VEHICLE FACTORS ATTACHMENT

Service Procedure G-05514-R2

G-05514-R2
February 2006

**SUBJECT: SAFETY RECALL (U.S., EXPORT)
BATTERY CABLES on 9000 models built 4/1/2002
thru 6/15/2005**

Figure 1 – Gap Measurement

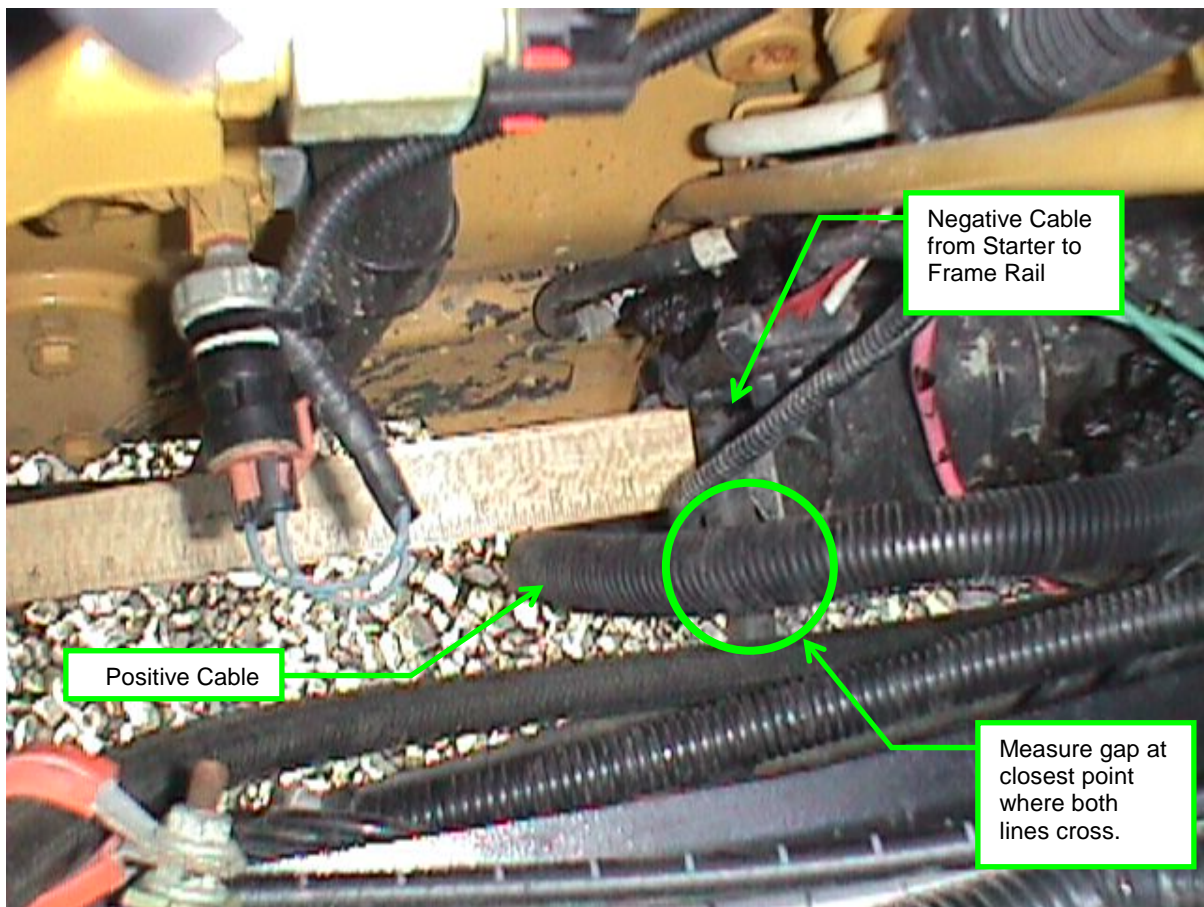
1. For Cummins ISM w/ fuel filter, do not perform the gap measurement, skip to the **BATTERY CABLE INSPECTION PROCEDURE**.
2. For Caterpillar, Cummins ISX, and Cummins ISM w/o fuel filter, perform the following gap measurement.
3. Measure the smallest gap between the positive cable's conduit and the closest point to the negative cable bolted to the frame rail. See Figure 1.

4. If the smallest gap is less than 1.5 inches (38mm) continue on to **BATTERY CABLE INSPECTION PROCEDURE.**

Figure 5 – w/o fuel filter

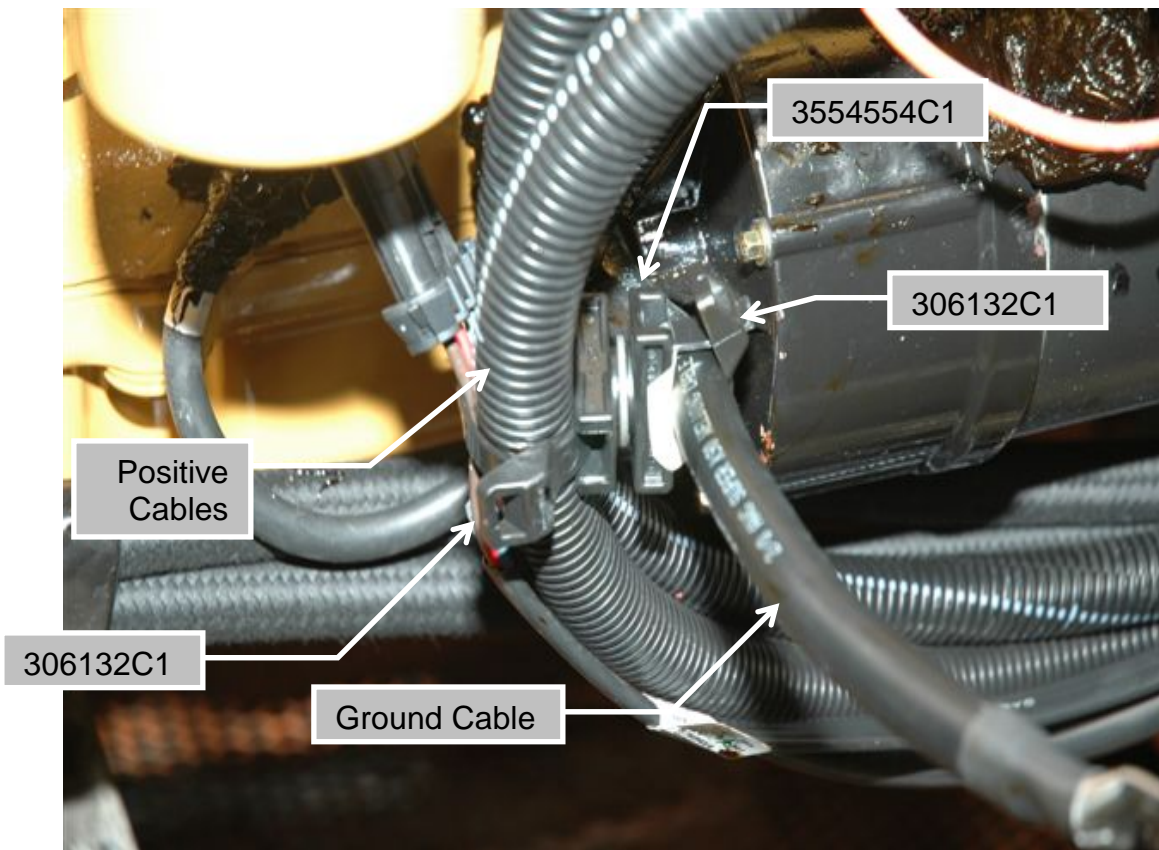
10. For Caterpillar, Cummins ISX, and Cummins ISM (w/o fuel filter), see Figure 5.

11. Install saddle clamp and strap-locks as indicated below:

Figure 6 – Cummins ISM w/Fuel Filter

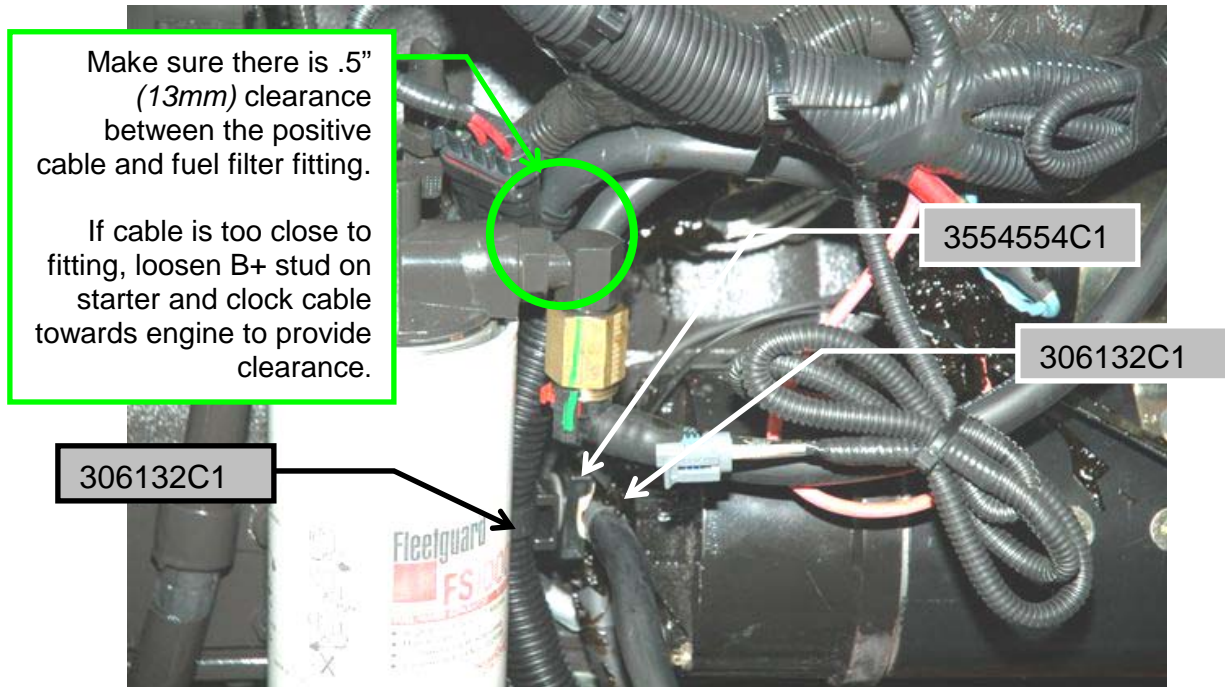
12. For Cummins ISM engines with fuel filter please see Figure 6.

13. Install saddle clamp and strap locks as indicated below.

14. Re-route battery cables between the fuel filter and engine block.

NOTE: Ensure battery cables do not touch fuel filter assembly or fittings.

**Figure 7 --
Chafing may occur between Engine Block Ground and Newly Located Positive cables.**

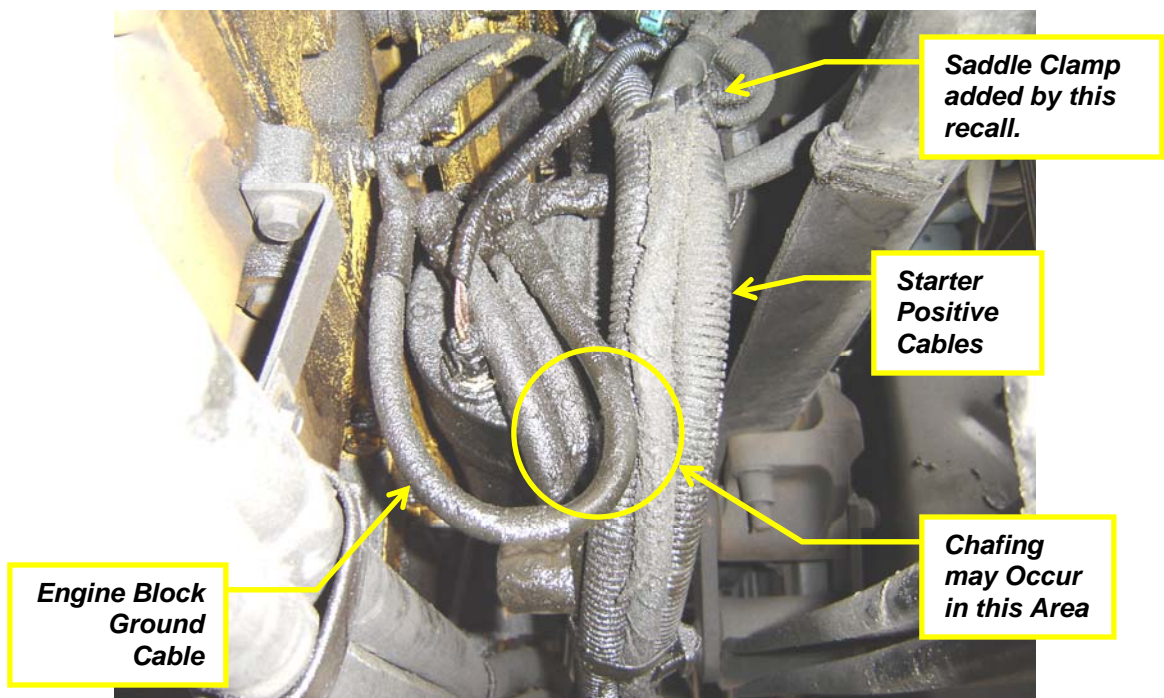
TO PREVENT CHAFING OF THE POSITIVE CABLES AGAINST THE ENGINE BLOCK GROUND CABLE (SEE FIGURE 7), PLEASE ENSURE ENGINE BLOCK GROUND CABLE IS CLOCKED IN THE DOWNWARD (6 O'CLOCK) POSITION, SEE FIGURE 8.

NOTE: *If NO rubbing or chafing is present between CAT ENGINE GROUND cable and battery cables, NO re-clocking is necessary.*

- ***If rubbing or chafing of the ENGINE GROUND cable against the Battery Cables is present, rotate and tighten the new ground cable on the starter terminal so it is straight down (6 o'clock position) and not contacting the starter positive cables, see figure 8.***

Figure 8a – Correct CAT C15 engine block ground cable routing.

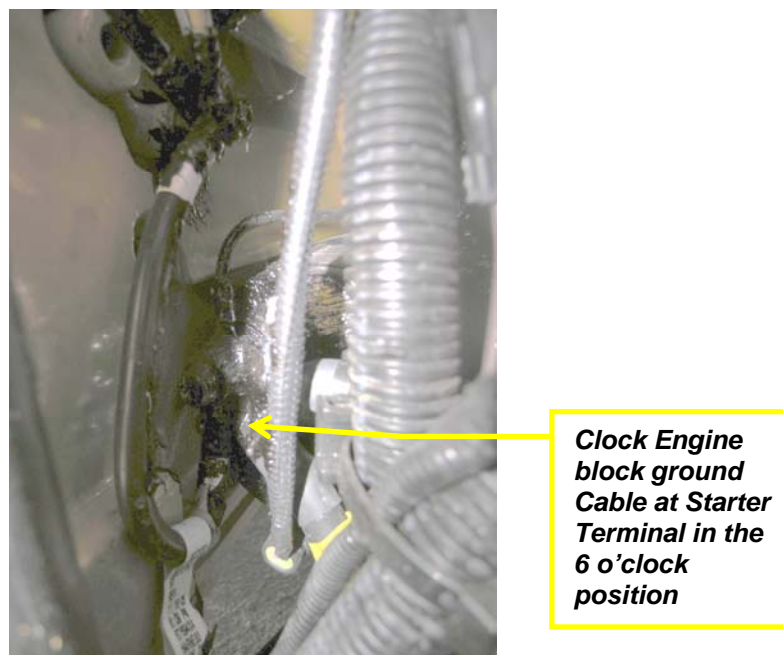
- Added the FINAL INSPECTION to the ***INSPECTION/REPLACEMENT PROCEDURE TABLE***.
- Modified Step 5.
- Added **NOTE** below ***SADDLE CLAMP INSTALLATION***.
- Modified ***Caterpillar® Engine Warning***
 - Added **NOTE** below Figure 7.
 - Re-worded clocking step.
- Added **Figure 8a**.
- Added ***FINAL INSPECTION***.
